Title:
CC1352-P7EM-XD7793-XD24-PA24

Size: A3 Rev: B0 Sheet: 1 of 3

Date: Friday, October 09, 2020

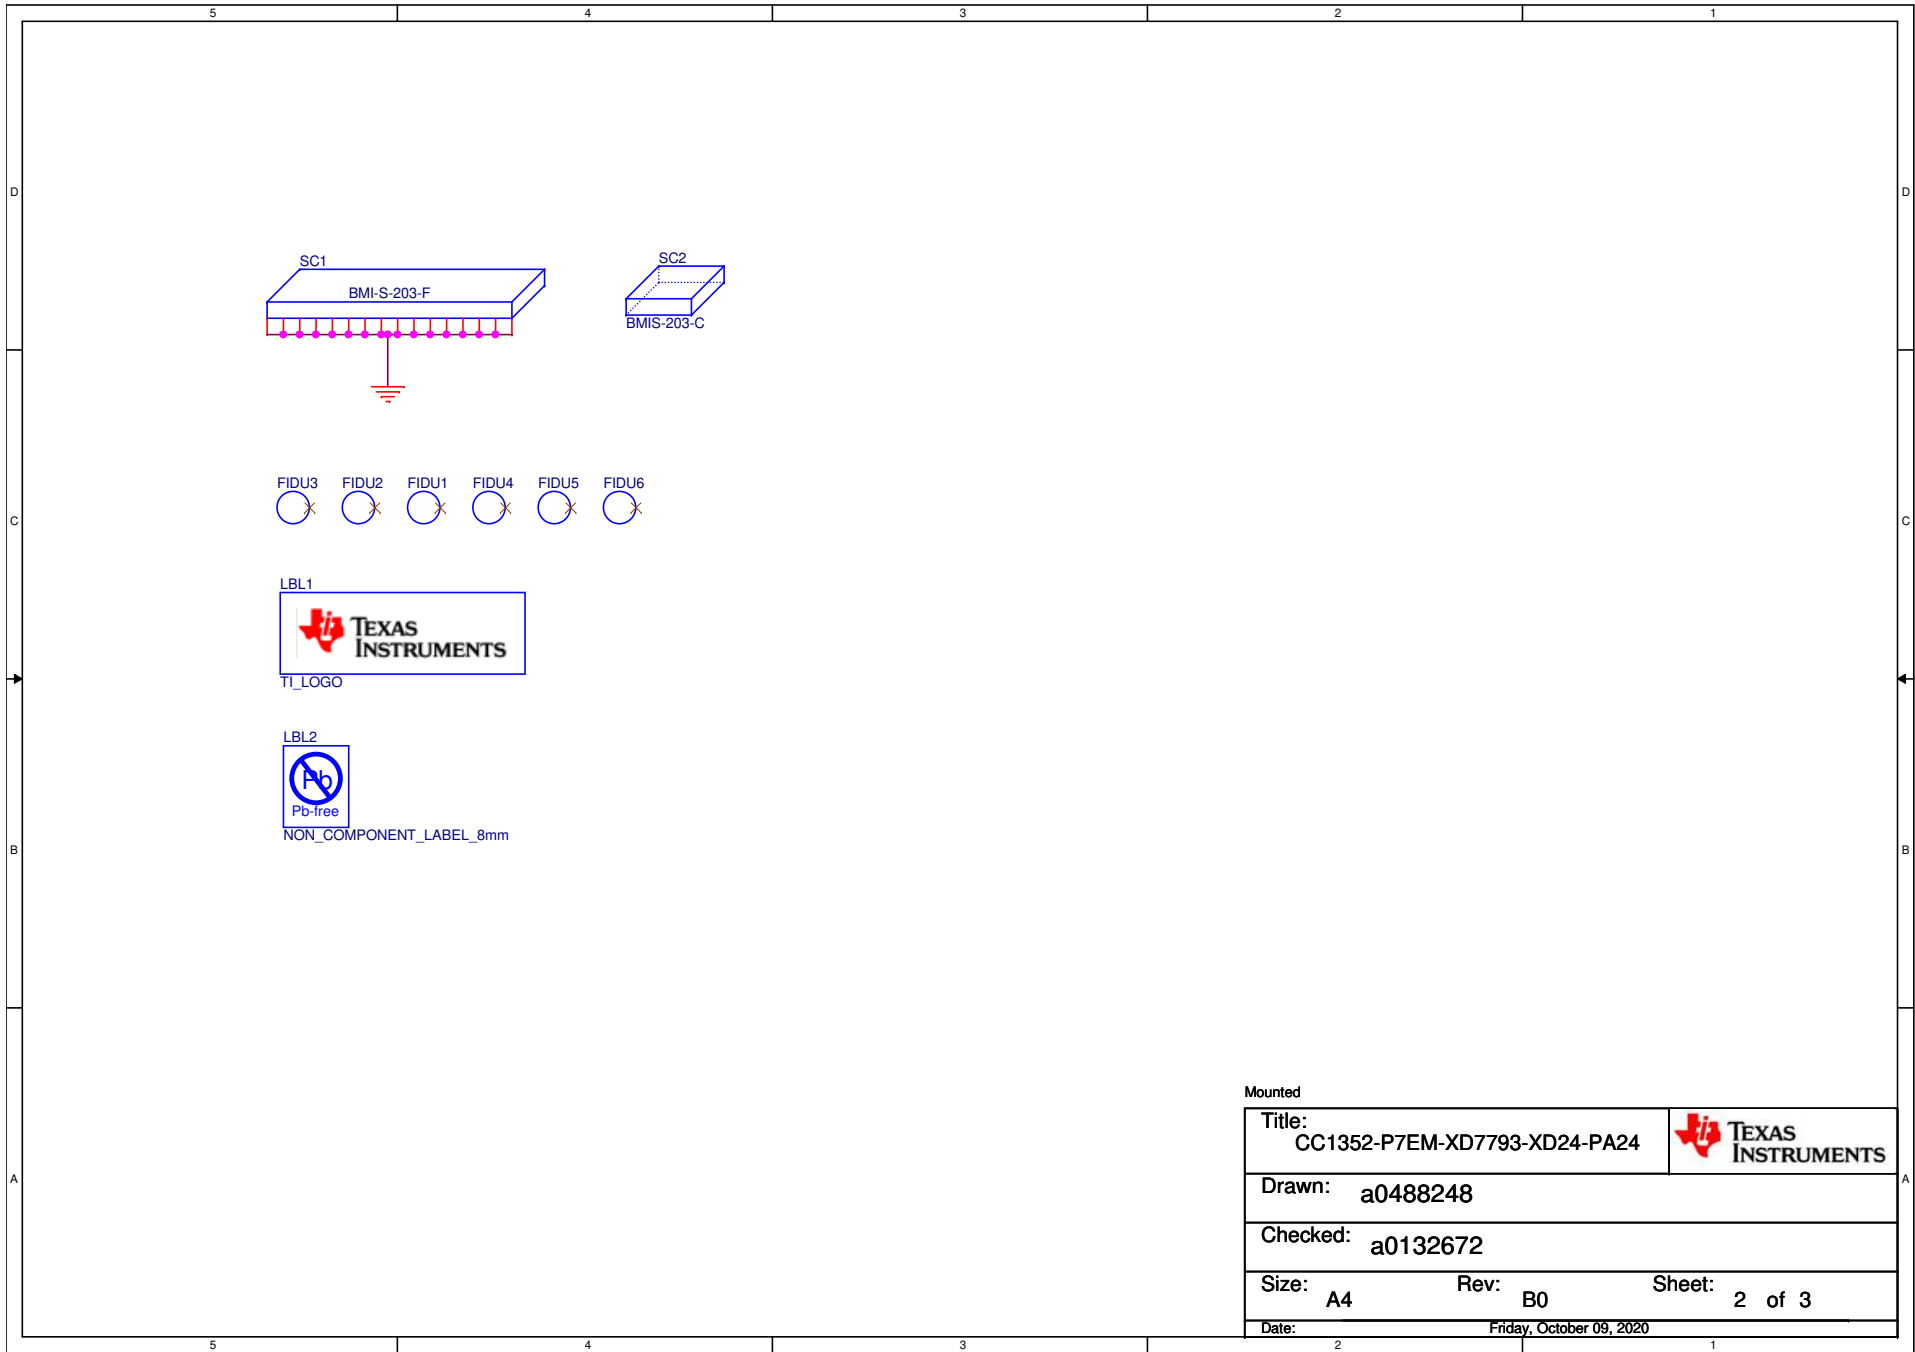
- Based on CC1352PEM-XD7793-XD24-PA24 revision C1.
- Changed C1 from GRM188R60J226MEA00 to GRM188C80J226ME15D
- Changed C11,C15,C51,C81,C91 from GRM1555C1H120JA01D to GJM1555C1H120JB01D

- Changed C12,C21 from GRM1555C1H1R1BA01D to GJM1555C1H1R1BB01D
- Changed C13,C14 from GRM1555C1H1R0BA01D to GJM1555C1H1R0BB01D
- Changed C16,C32,C36 from GRM1555C1H101JA01D to GRT1555C1H101JA02D

- Changed C31,C53,C61 from GRM1555C1H1R2BA01D to GJM1555C1H1R2BB01D
- Changed C33,C41 from GRM1555C1H3R0CA01D to GJM1555C1H3R0CB01D
- Changed C34 from GRM1555C1H2R7CA01D to GJM1555C1H2R7CB01D

- Changed C35 from GRM1555C1H5R6CA01D to GJM1555C1H5R6CB01D
- Changed C52 from GRM155R71E103KA01D to GRM155R71H103MA88D
- Changed C54 from GRM1555C1HR80BA01D to GJM1555C1HR80BB01D

- Changed C55,C56 from GRM1555C1H1R6BA01D to GJM1555C1H1R6BB01D
- Changed C57 from GRM1555C1H6R8CA01D to GJM1555C1H6R8BB01D
- Changed C231 from GRM155R61E105KA12D to GRM155C81C105KE11D

- Changed C331,C341 from GRM188R60J226MEA00 to GRM188C80J226ME15D
- Changed C461,C471 from GRM1555C1H7R5CA01D to GJM1555C1H7R5CB01D
- Changed U1 from CC1352P1F3RGZR to CC1352P1F64TRGZE

- Changed Y1 from FC-135 32.7680KA-AG0 to TZ1166C
- Changed Y2 from NX2016SA 48.000MHz EXS00A-CS05517 to TZ2365C

- Changed design name from CC1352P1F64EM-XD7793-XD24-PA24 to CC1352-P7EM-XD7793-XD24-PA24
- Updated CC1352P1F64TRGZE to CC1352P74TORGZR
